AMEREN ILLINOIS COMPANY

2023 BUSINESS PROGRAM IMPACT

EVALUATION REPORT

APPENDIX D: CUSTOM INITIATIVE PROJECT
REPORTS

Figure 2. Chilled Water Temperature Compared to Outdoor Air Temperature and Estimated Reset

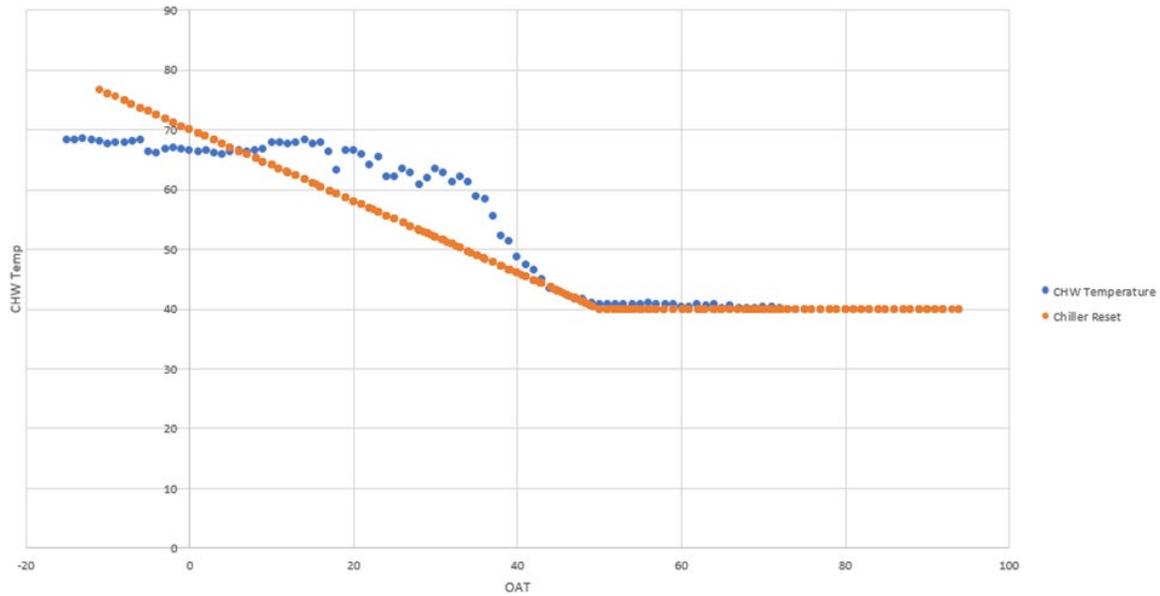
As mentioned in the early review, the curve used to calculate the chilled water reset savings had a couple of outliers that could improve the fit. The outliers were removed from the plot, which did not yield a significant change in savings. The data did not include the chilled water setpoints, and the actual chilled water temperature was plotted against the OAT, refer to Figure 2.

The implementer estimated the reset using a slope equation based on the expected chiller operation, specifically 46 °F at 45 °F OAT and 42 °F at 70 °F OAT. The evaluation team has adjusted the slope equation by looking at the chilled water temperatures at an OAT of 45° and 50 °F, representing the OAT range where the water temperature flattens out. This equate to chilled water temperatures of 43 °F and 40 °F, respectively. The resulting adjustment yields 1,515 kWh in annual savings for the chilled water temperature reset controls. The savings per unit can be seen in Table 9.

Figure 4. Motor PF vs. Motor LF

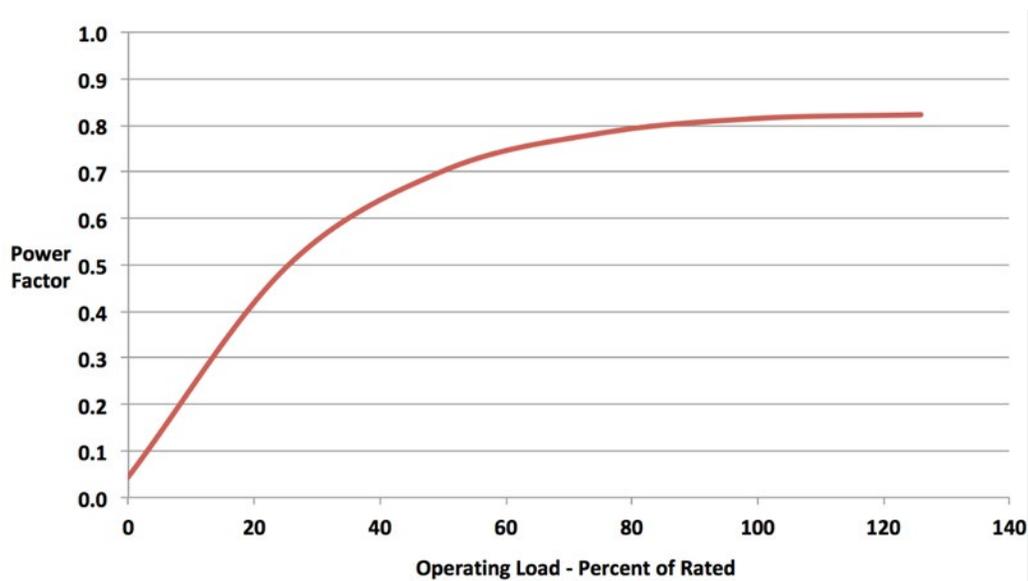
- Evaluation Finding: Metering, as described above, was not performed to further verify values used through the ex ante calculations. More importantly, the implementer did not verify the PF used in the baseline and proposed conditions. The customer reported that the facility has a capacitor bank for PF correction, and it appears that the implementation team may have used the facility PF for both cases. The facility PF is not representative of motor PF, particularly at the low load factors expected by lightly loaded motors. A typical power factor as a function of motor load can be seen in Figure 4.

Figure 7. AHU-1 Supply Air Static Pressure Reset Screenshot

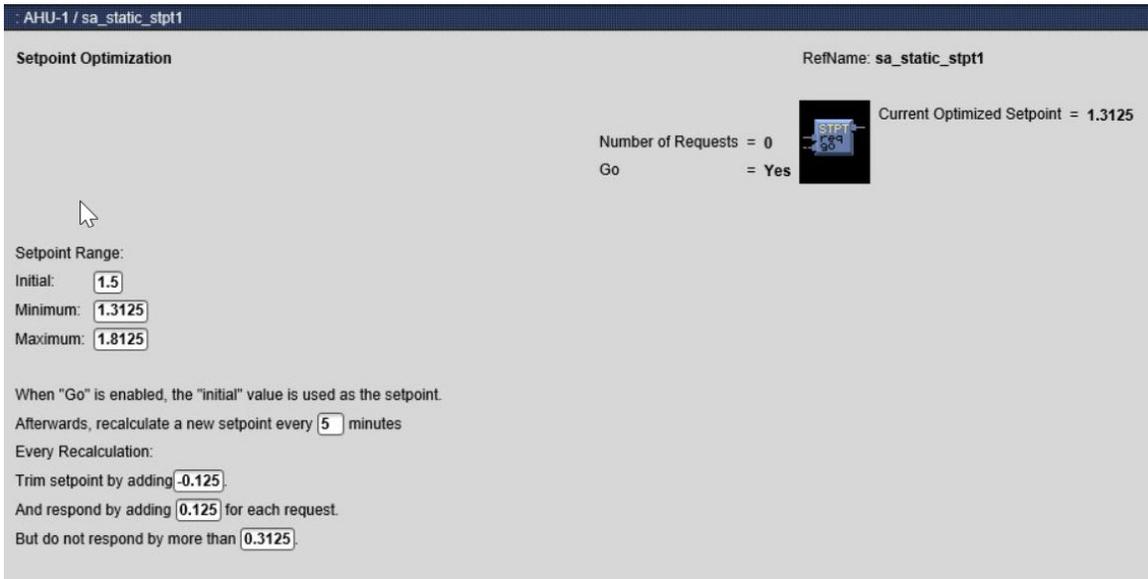
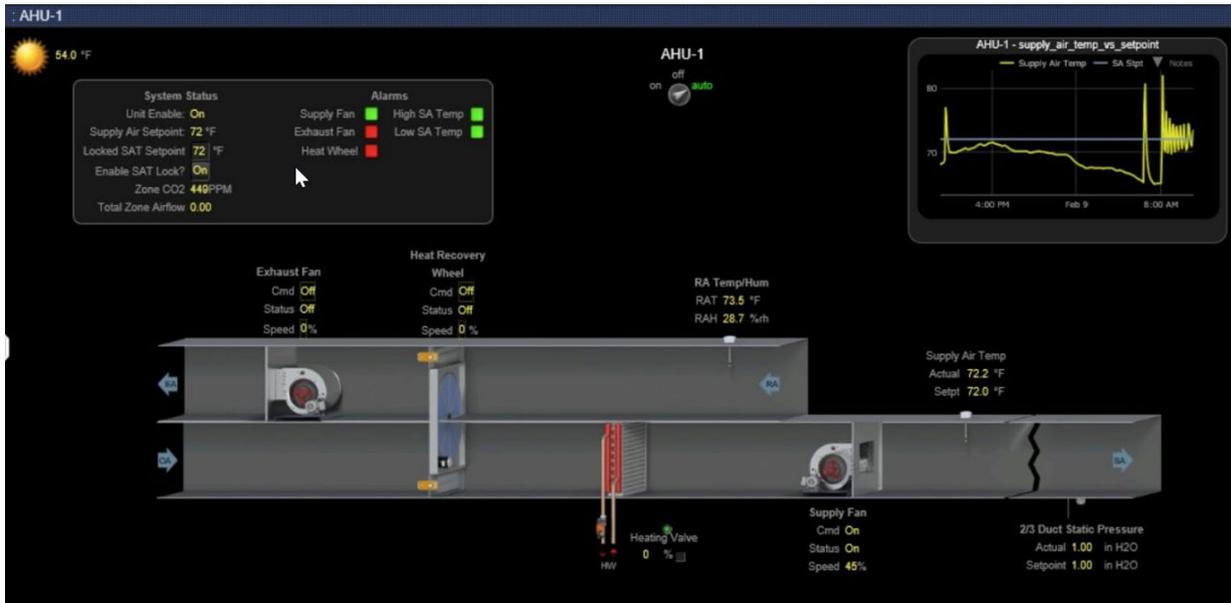
Based on the BAS screenshots, it can be seen for AHU-1 that the current optimized setpoint for supply air static pressure from the control sequence (1.3125" W.C. in Figure 7) is different than the setpoint that the AHU is controlling

the fan speed for (1.00" W.C. in Figure 8). This indicates that the system is not actually using the static pressure reset controls, and it is believed that the fans are maintaining a constant static pressure all the time.

Figure 11. AHU-3 Supply Air Static Pressure Reset Screenshot

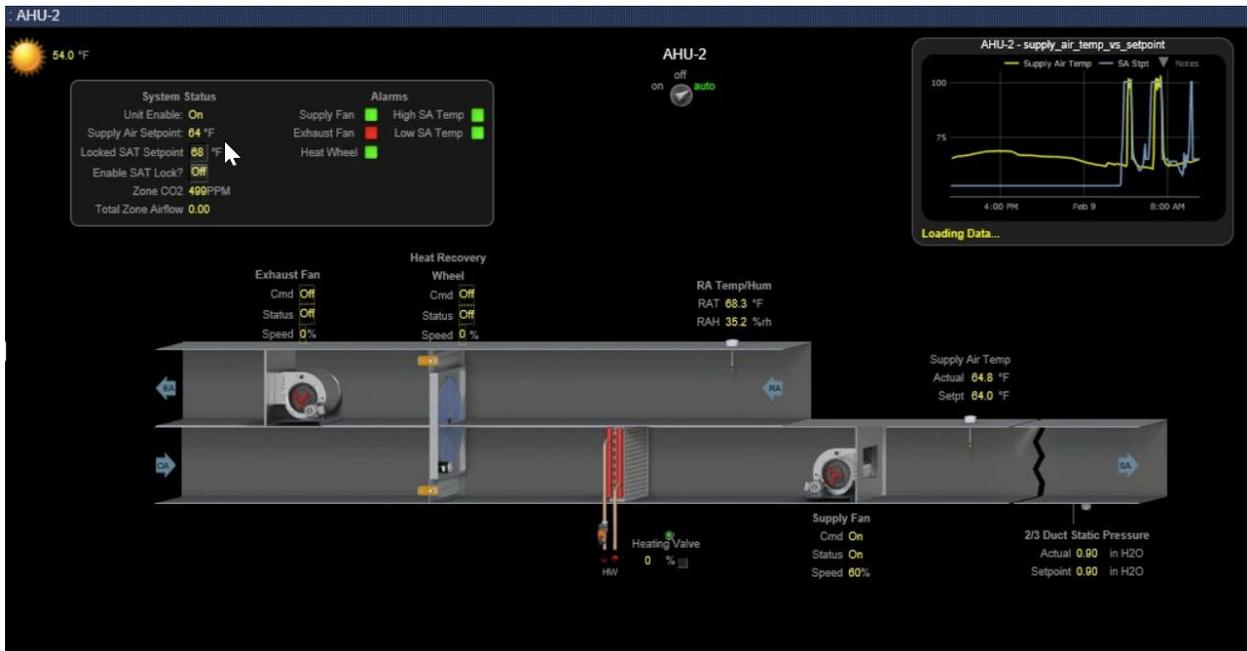
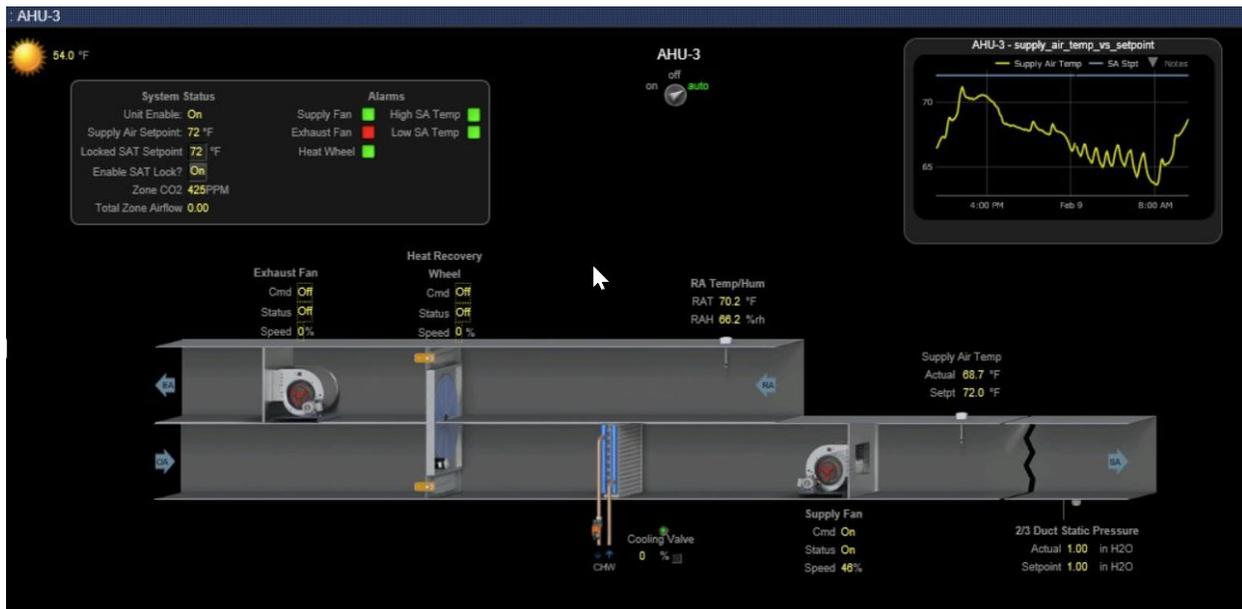
A similar variation from the optimized static reset setpoint to the actual static setpoint can be seen for AHU-2 (Figure 9 and Figure 10) and AHU-3 (Figure 11 and Figure 12).

Figure 14. AHU-1 Supply Temperature Setpoint Control Logic

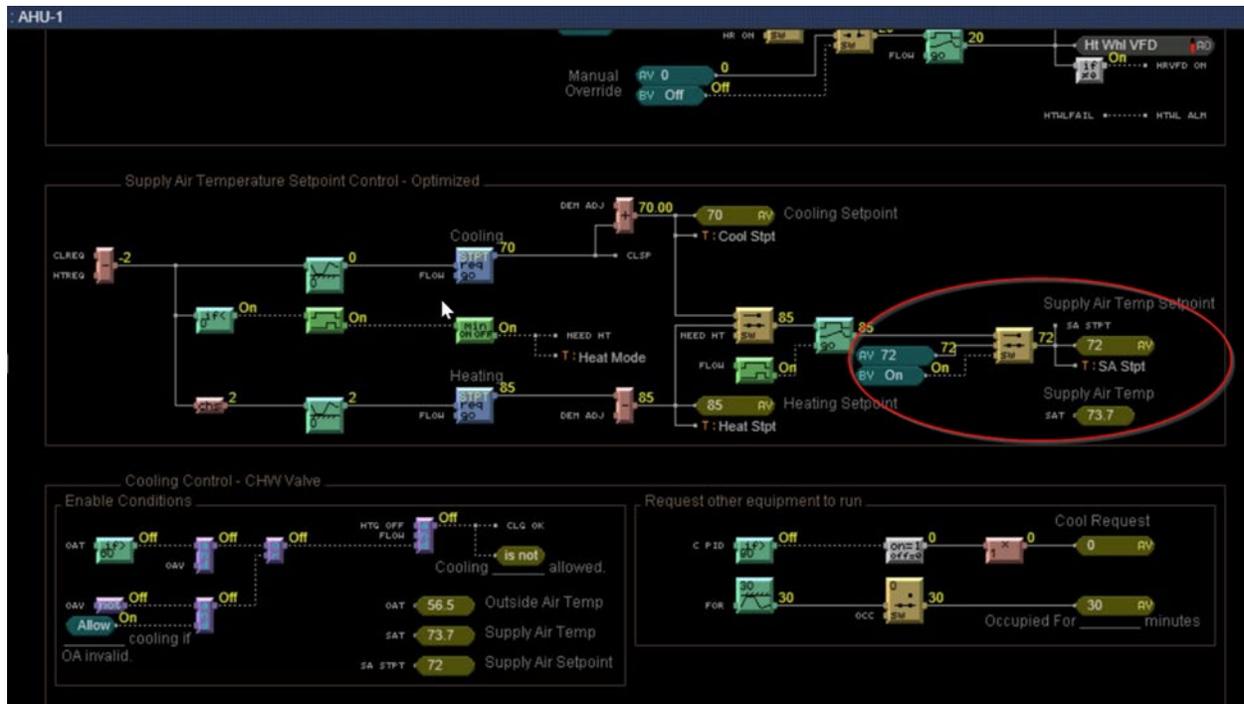
Supply temperature setpoints for AHU-1 and AHU-3 can be seen as constant on the top right corner of the BAS graphics (Figure 8 and Figure 12) while the supply temperature varies. Also, after looking through the supply temperature setpoint control logic, there seems to be a manual override (Analog Value AV) on the setpoint (see Figure 14). Based on this information, it is evident that the supply temperature setpoints for AHUs 1 and 3 are manually overridden, negating savings from the supply temperature setpoint reset.

From Jan-Feb 2024, trends for these three units show that the AHU-2 supply temperature varies considerably. Due to a lack of data, the real reason behind this variation is unclear, but as per the vendor, it could be that the heating valve BAS output is hunting for its setpoint and may need optimizing. The vendor also informed the evaluation team that while modulating, the heating valve for AHU-2 is set to stay open at a minimum position to heat even on a 0% valve command for HW loop balancing purposes in heating mode.

Although there seems to be a supply air temperature reset for AHU-2, the vendor has not determined whether the customer has modified the reset schedule. Since the supply temperature is already based on zone heating/cooling demand and the VAV boxes are cooling-only boxes without reheat, the evaluation team assumed a zone temperature heating/cooling deadband would control the supply temperature and developed a separate spreadsheet-based calculation. As mentioned above, this zone temperature heating-cooling deadband has not been taken for AHU-1 and 3 calculations since their supply setpoints have been fixed manually.
